Re: St. Paul's School – Admission Center (PL-AMEND-2025-0015)
16 Dunbarton Rd. (325 Pleasant St.)
Map 723Z Lot 13-1

Below is a detailed timeline of the St. Paul's School Admission Center Project located at 16 Dunbarton Road, as requested in support of the Site Plan Amendment Application.

J - PL-AMEND-2025-0015 Application

1 EAST ELEVATION - GATHERING
1/8" = 1'-0"

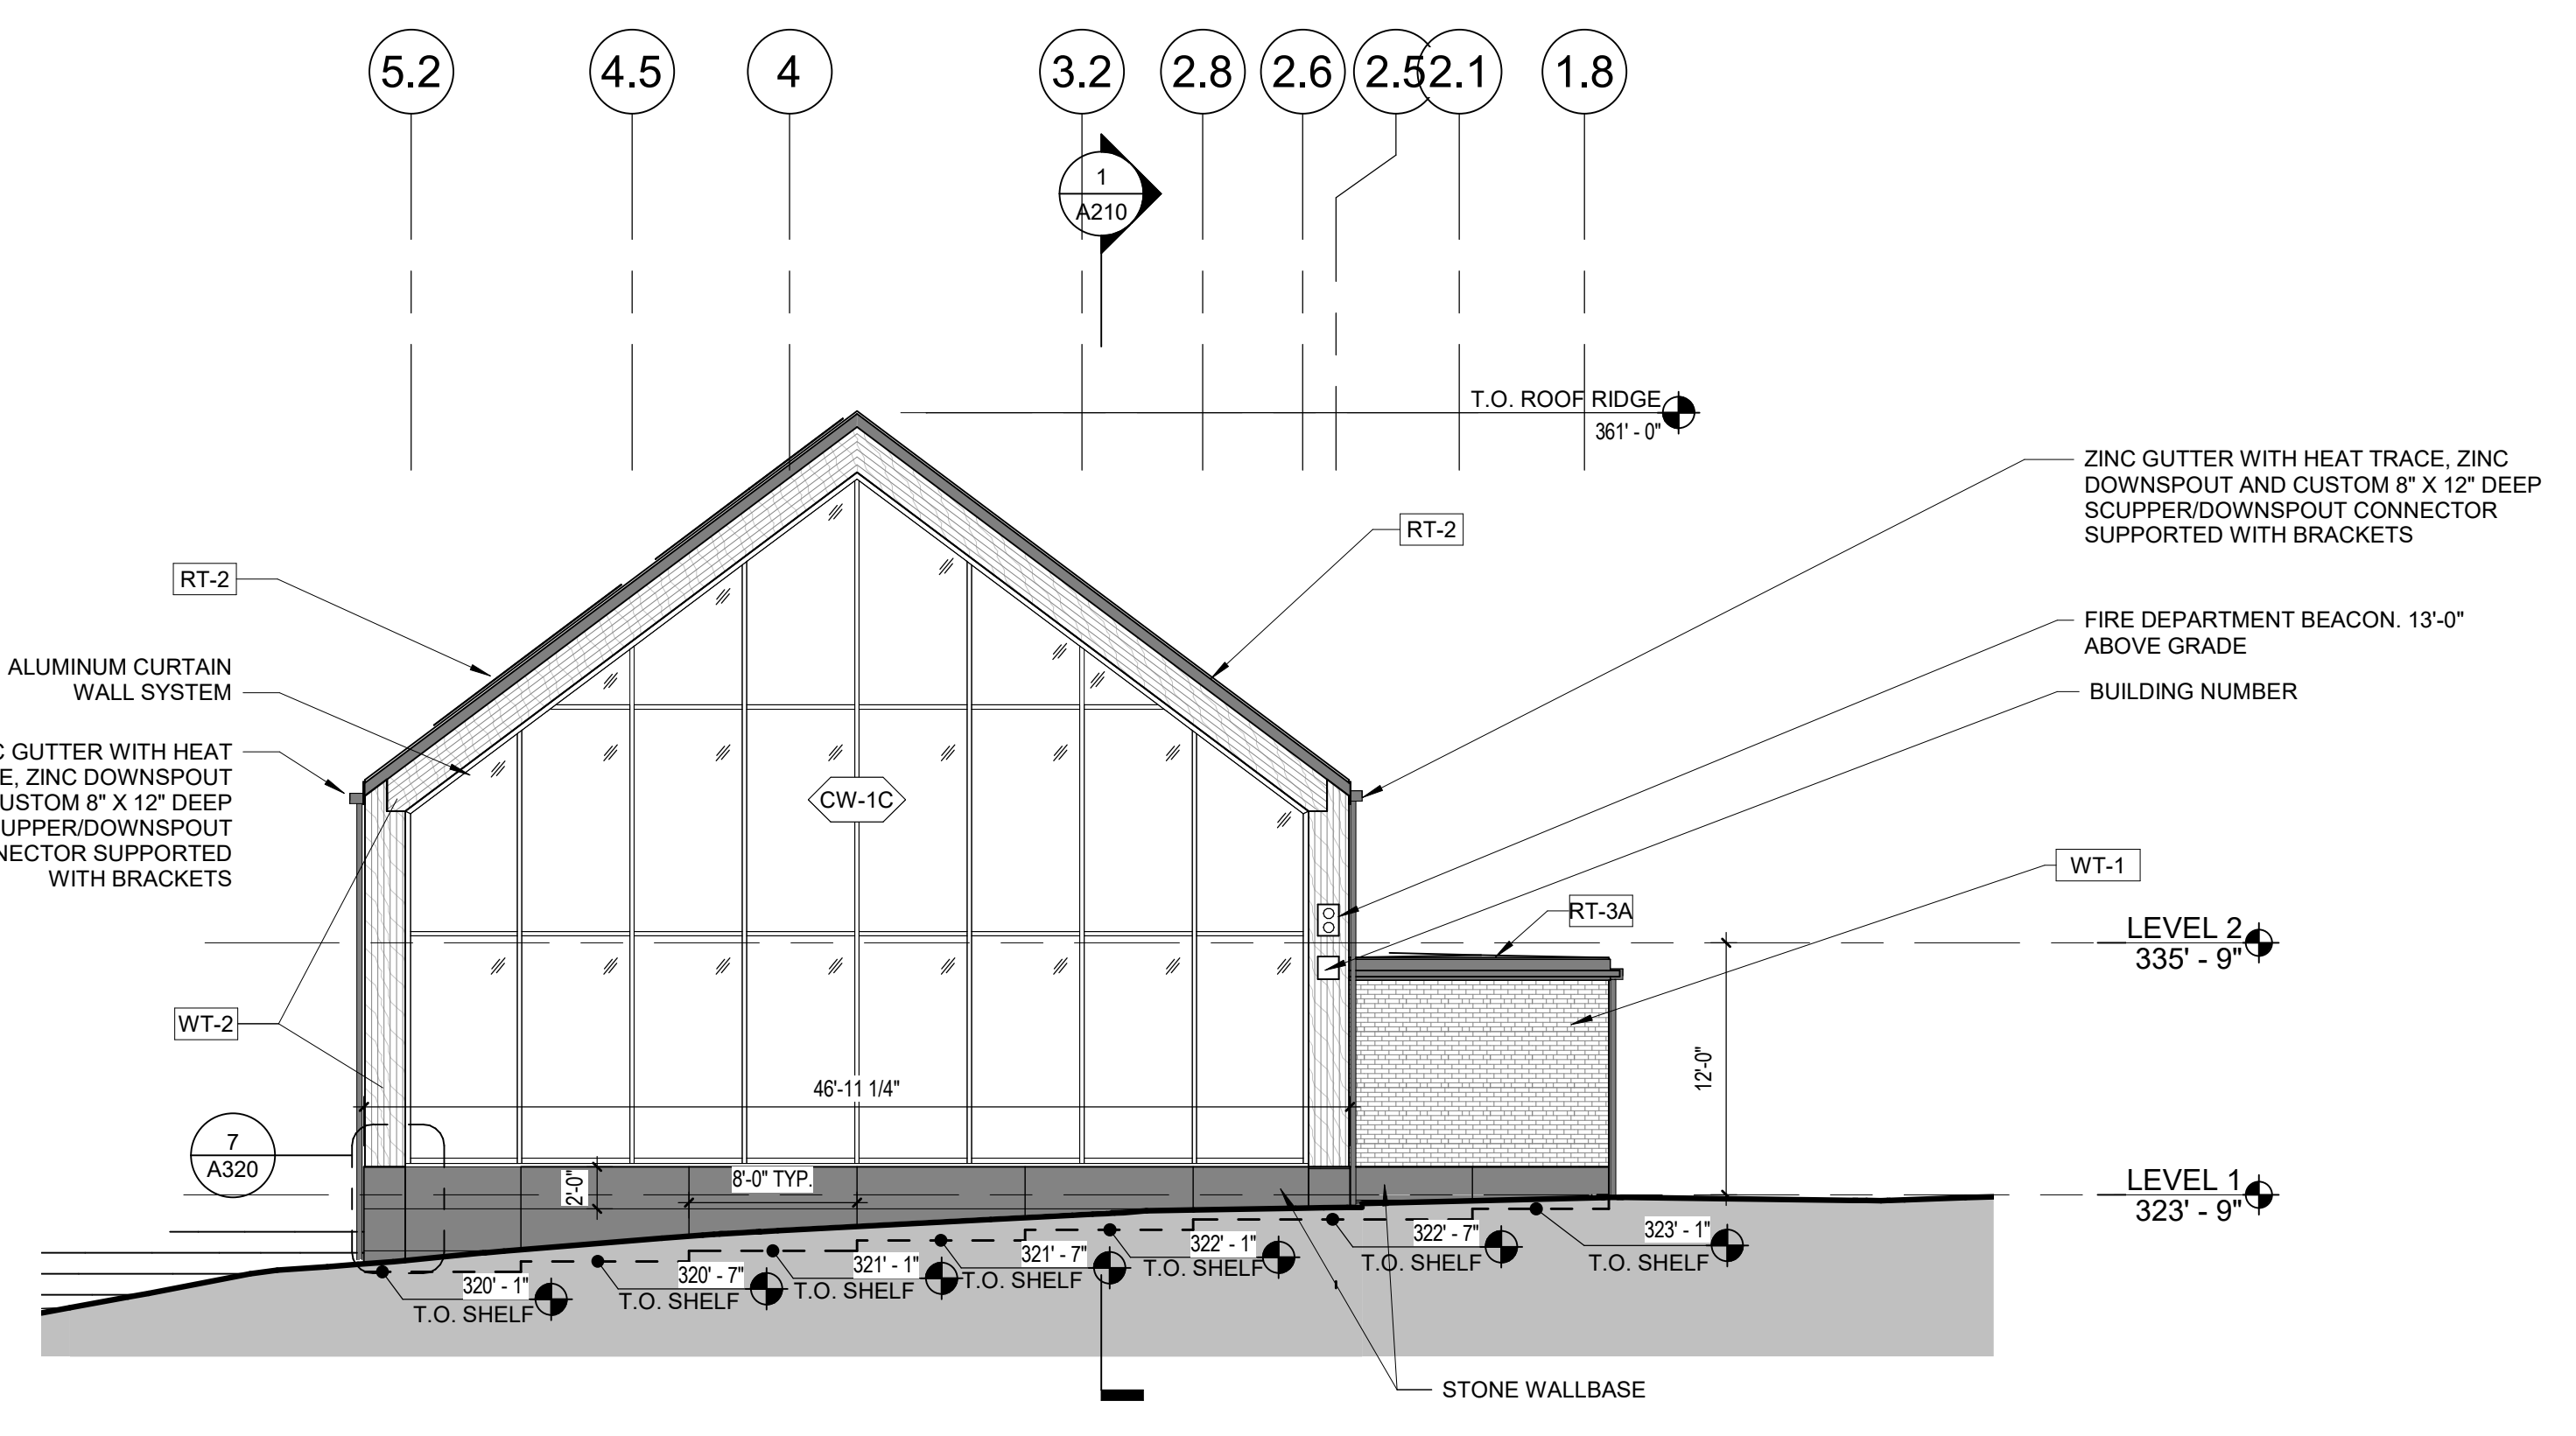
Pergola removed as part of value engineering.

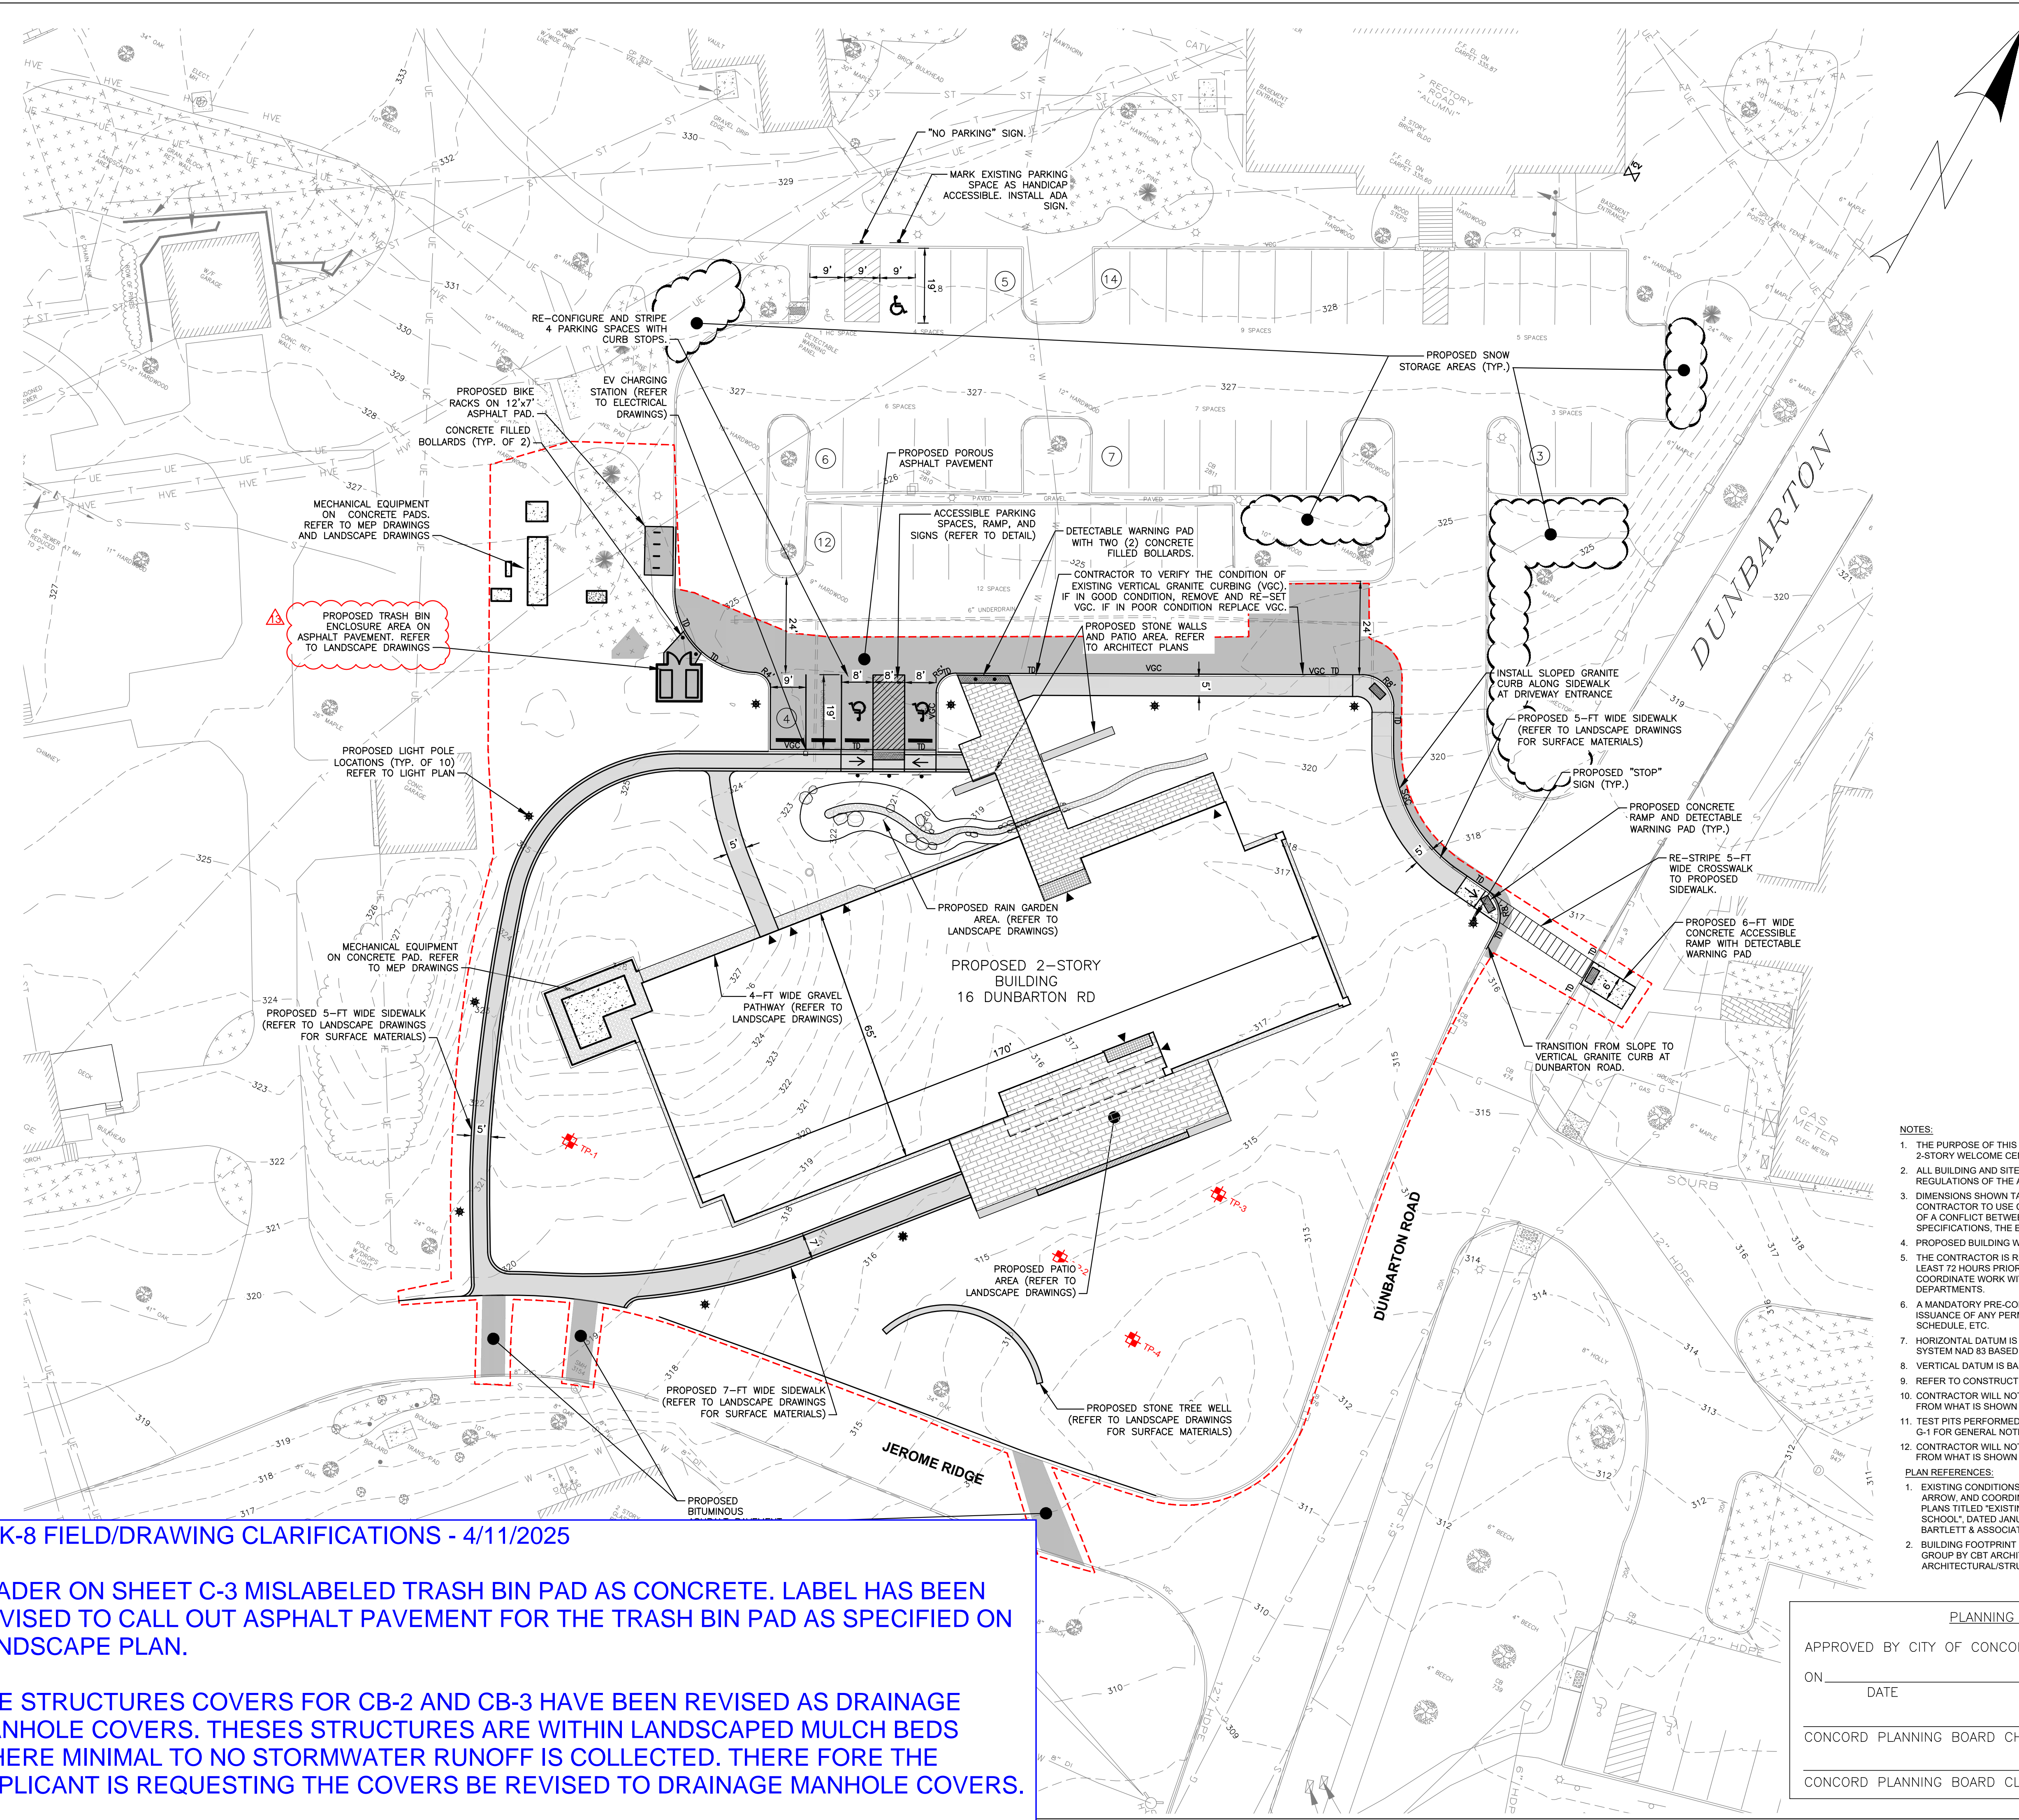
LEADER ON SHEET C-3 MISLABELED TRASH BIN PAD AS CONCRETE. LABEL HAS BEEN REVISED TO CALL OUT ASPHALT PAVEMENT FOR THE TRASH BIN PAD AS SPECIFIED ON LANDSCAPE PLAN.

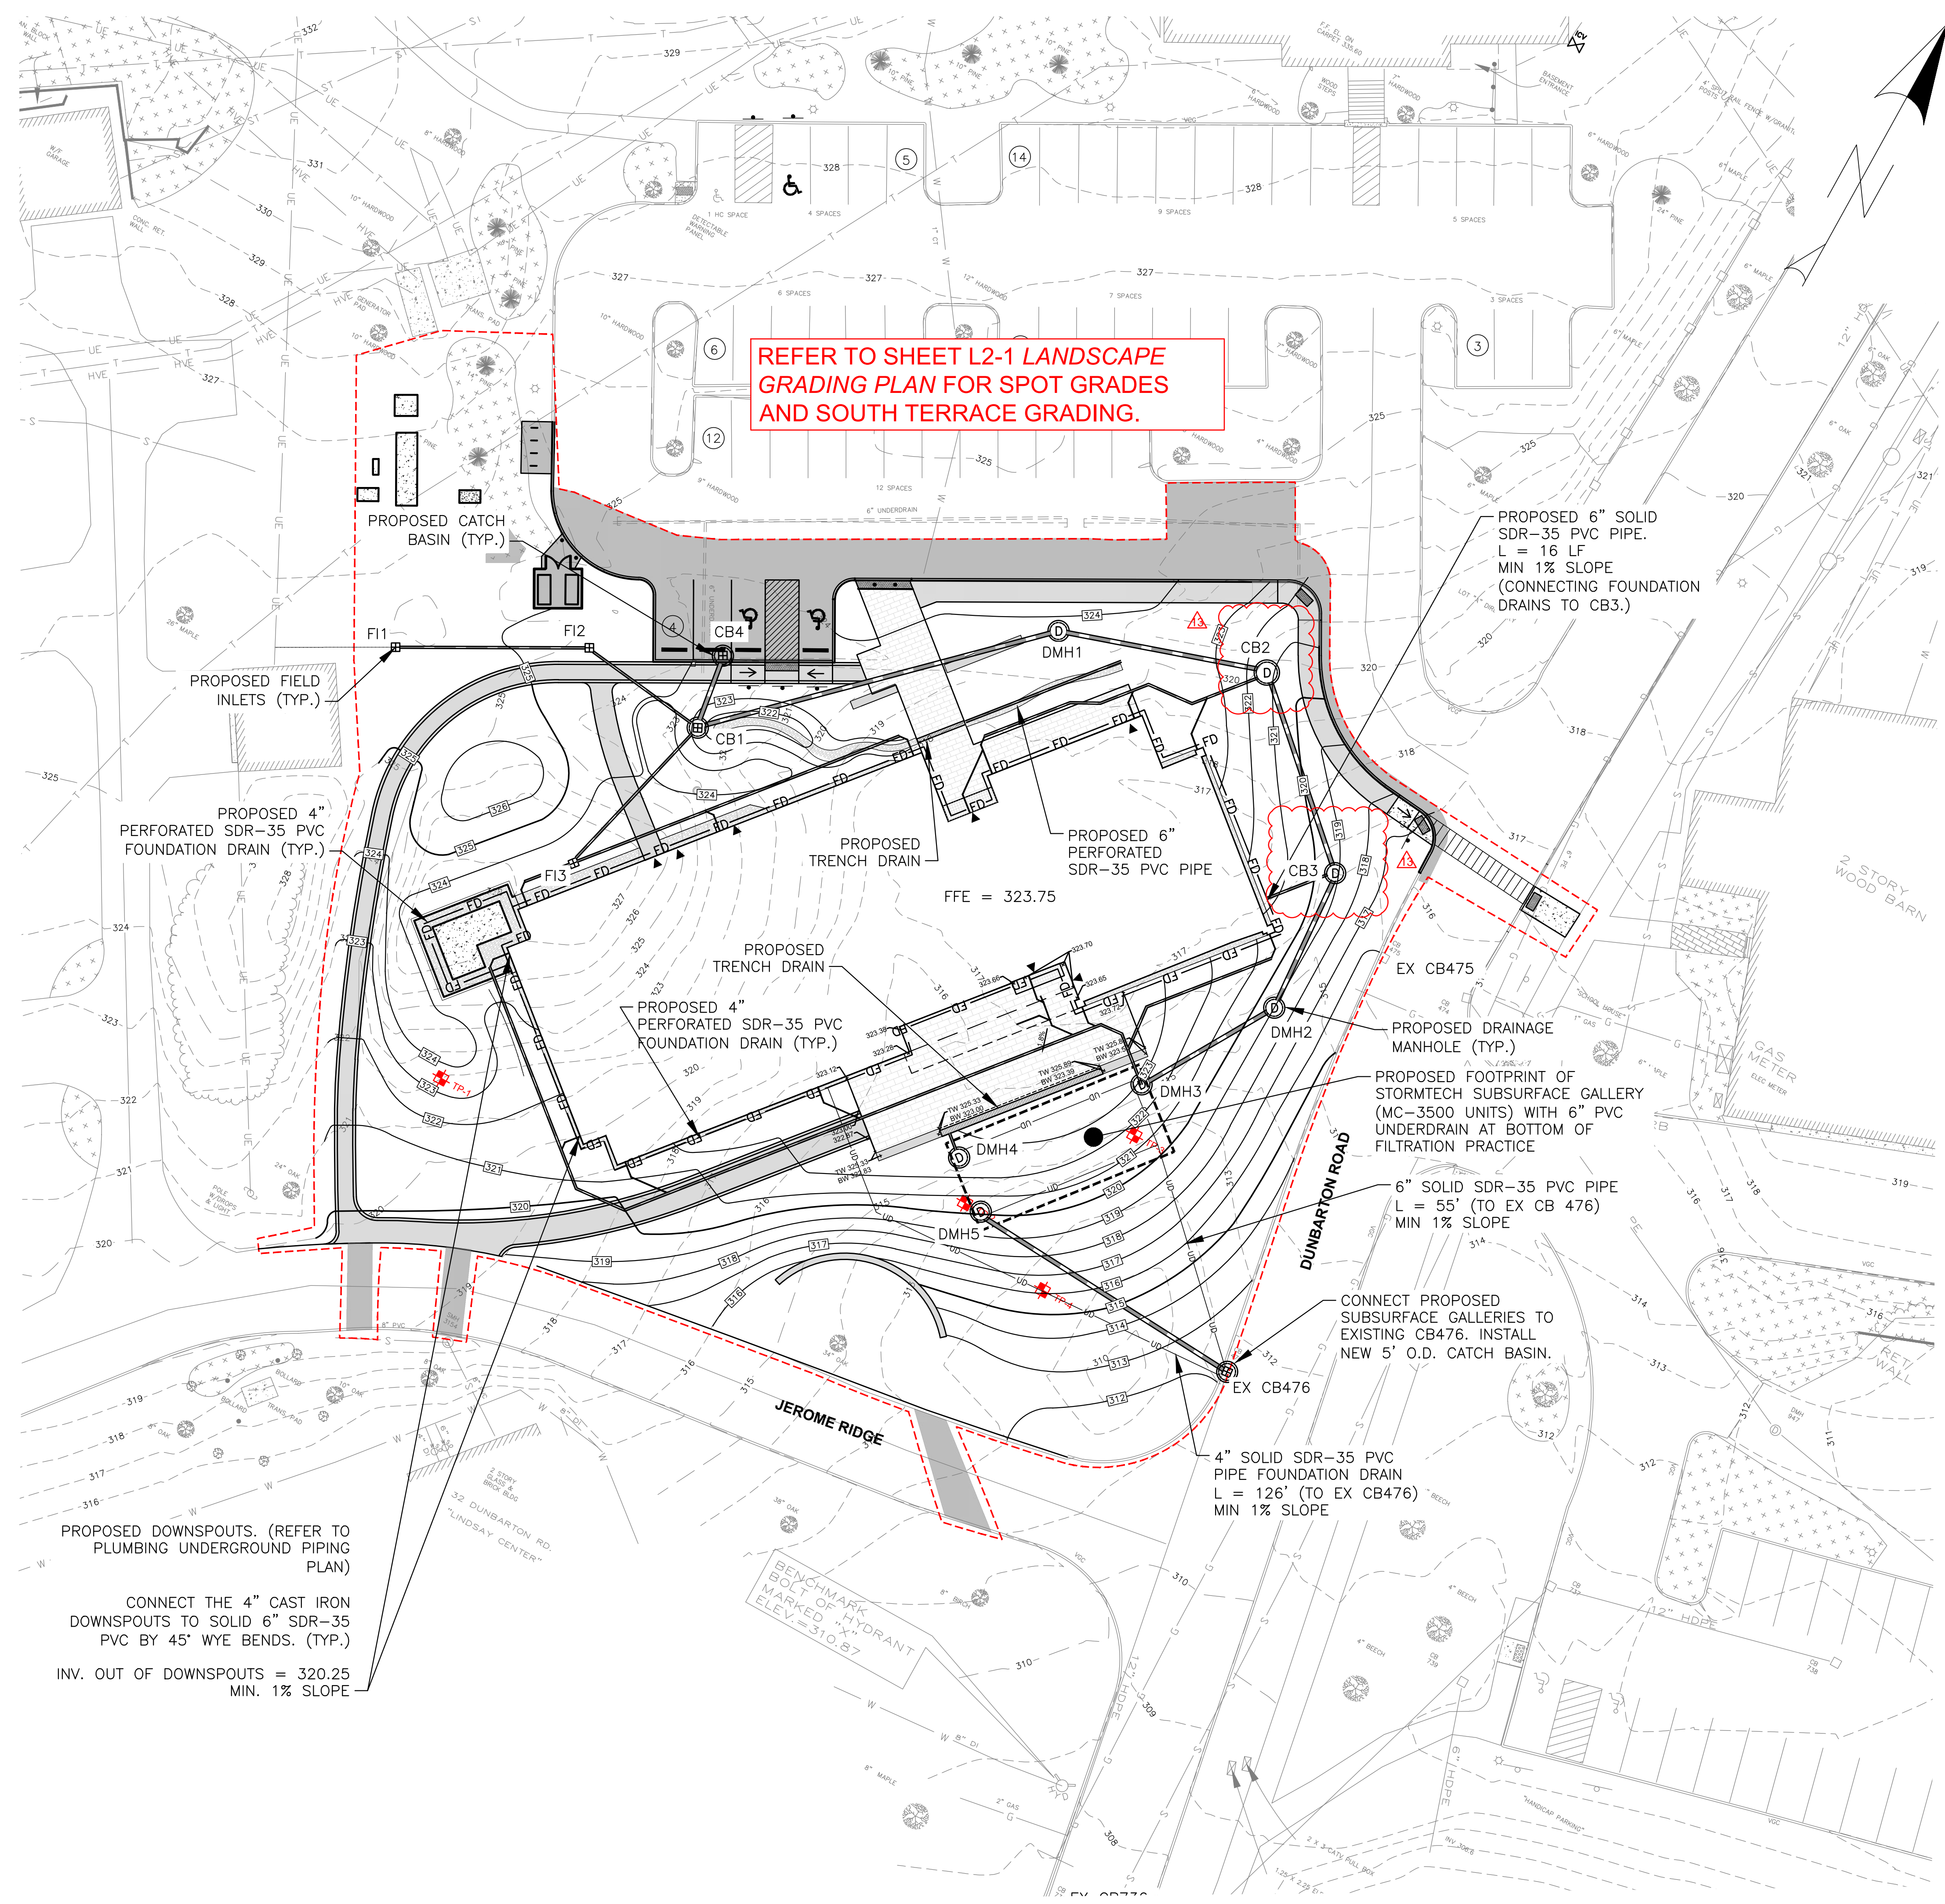
THE STRUCTURES COVERS FOR CB-2 AND CB-3 HAVE BEEN REVISED AS DRAINAGE MANHOLE COVERS. THESE STRUCTURES ARE WITHIN LANDSCAPED MULCH BEDS WHERE MINIMAL TO NO STORMWATER RUNOFF IS COLLECTED. THERE FORE THE APPLICANT IS REQUESTING THE COVERS BE REVISED TO DRAINAGE MANHOLE COVERS.
